Model: LDT, LHT 036H - 072H Y VOLT HEATPUMP - EBM BLOWER WITH HIGHER SCCR
Voltage: 208-240V/3~/60Hz (Y)
Supersedes: N/A Form No: 538199-01 Rev: 4

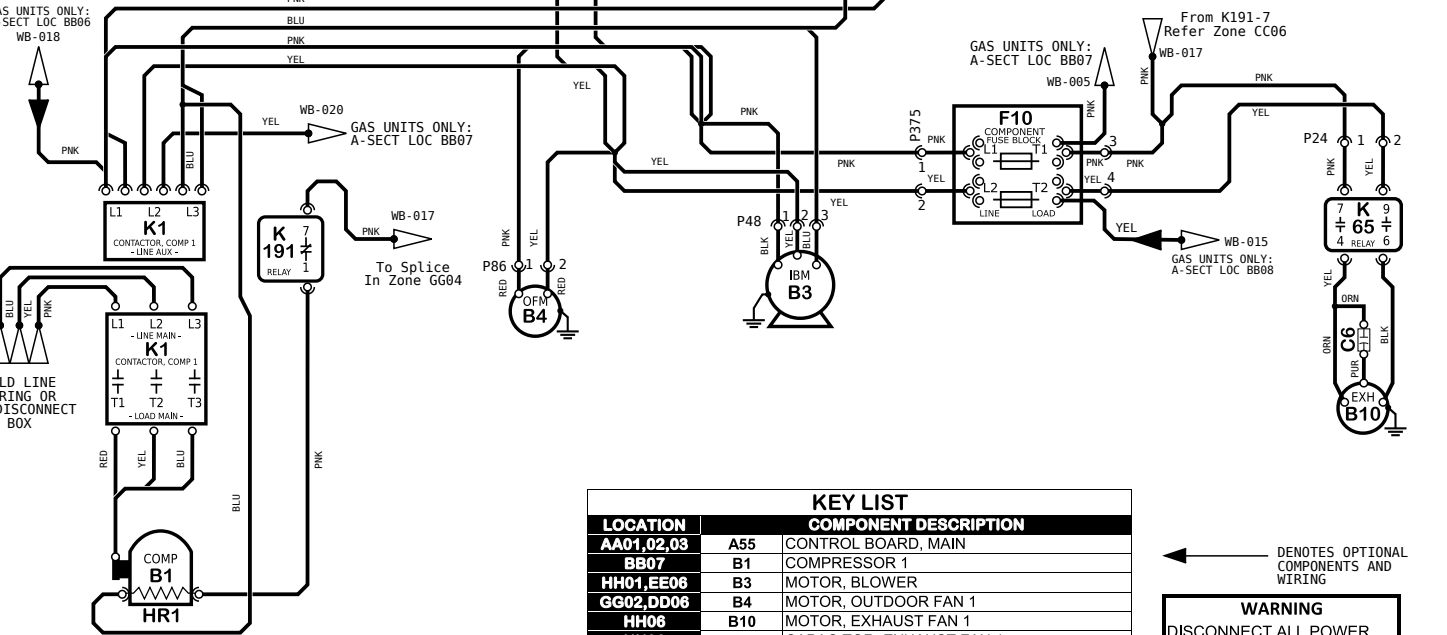
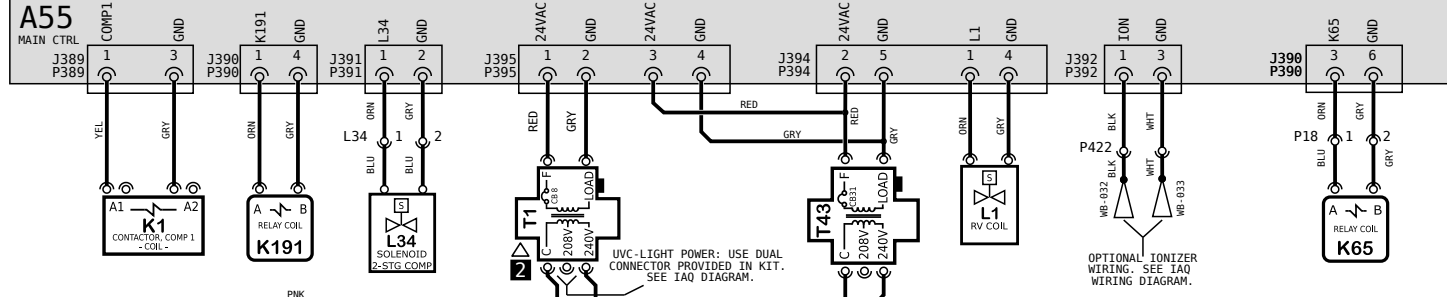
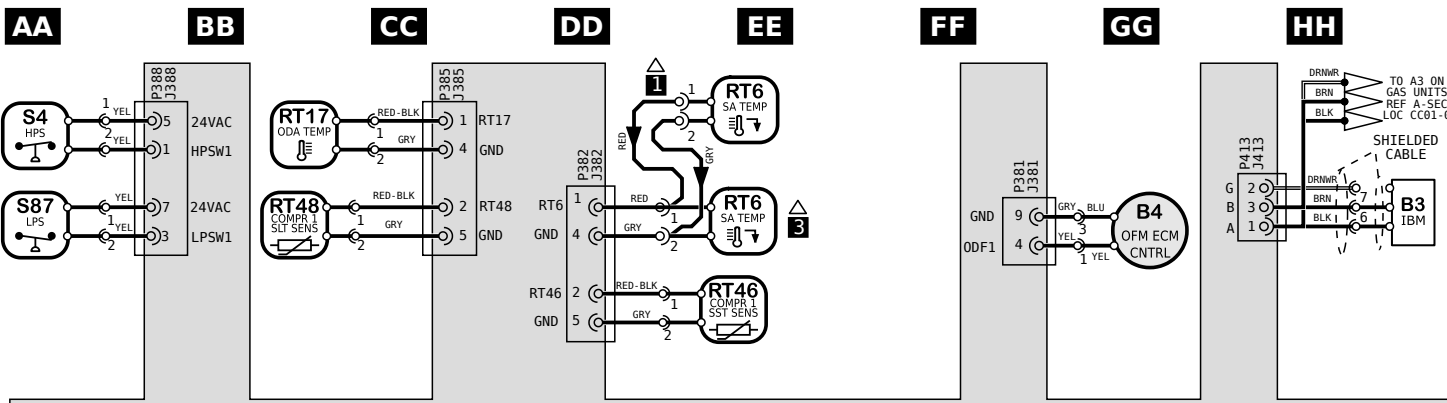
| REV | EC NO. | DATE | BY | APVD | REVISION NOTE |
|-----|------------|------------|-----|------|---|
| 003 | CN-014014F | 1/6/2026 | ZN | AWH | A) CLEANED UP WIRES TO GAS SECTION (A-SECT) |
| 004 | CN-013731A | 3/3/2026 | ZN | HMT | A) ADDED NOTE 3 FOR MODULATING GAS HEAT |

| NOTES | |
|-------|--|
| 3 | FOR MODULATING GAS HEAT UNIT ONLY, REFER TO RT6 AS SHOWN IN THE HEATING WIRING DIAGRAM (A-SECTION) |

Model: LDT, LHT 036H - 072H Y VOLT HEATPUMP - EBM BLOWER WITH HIGHER SCCR
Voltage: 208-240V/3~/60Hz (Y)
Supersedes: N/A Form No: 538199-01 Rev: 4

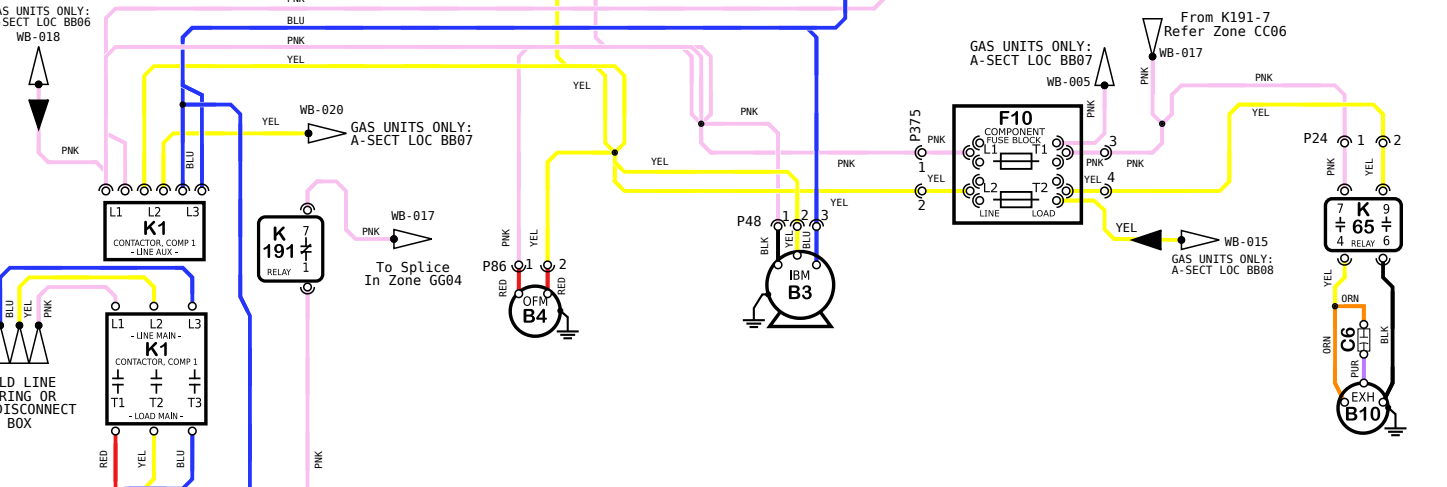
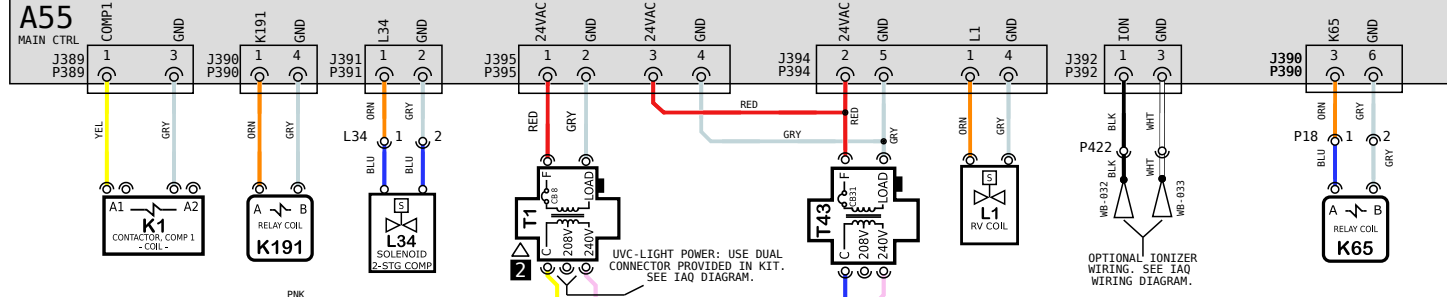
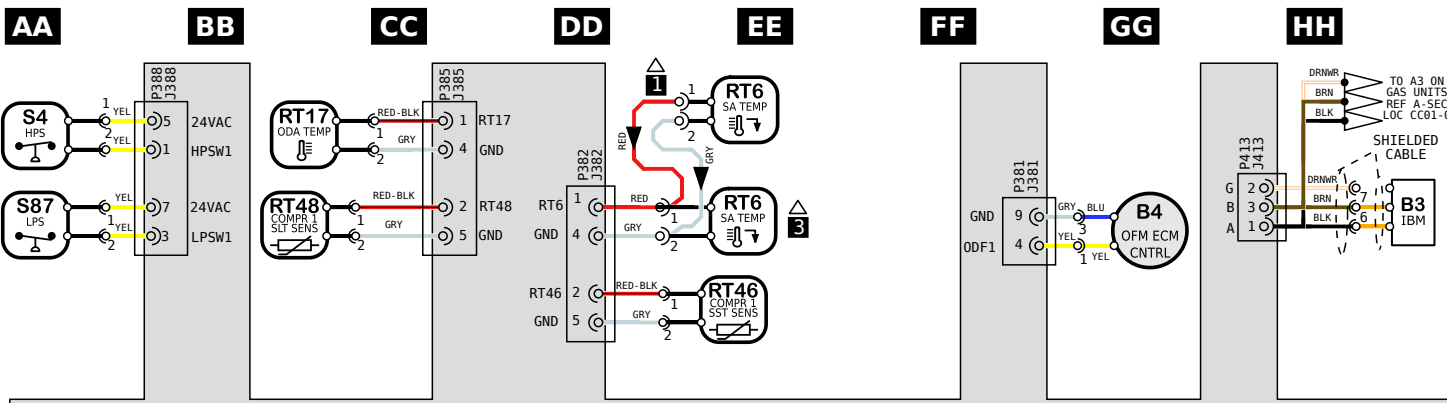
| REV | EC NO. | DATE | BY | APVD | REVISION NOTE |
|-----|------------|------------|-----|------|---|
| 003 | CN-014014F | 1/6/2026 | ZN | AWH | A) CLEANED UP WIRES TO GAS SECTION (A-SECT) |
| 004 | CN-013731A | 3/3/2026 | ZN | HMT | A) ADDED NOTE 3 FOR MODULATING GAS HEAT |

| NOTES | |
|-------|--|
| 2 | FOR MODULATING GAS HEAT UNIT ONLY, REFER TO RT6 AS SHOWN IN THE HEATING WIRING DIAGRAM (A-SECTION) |
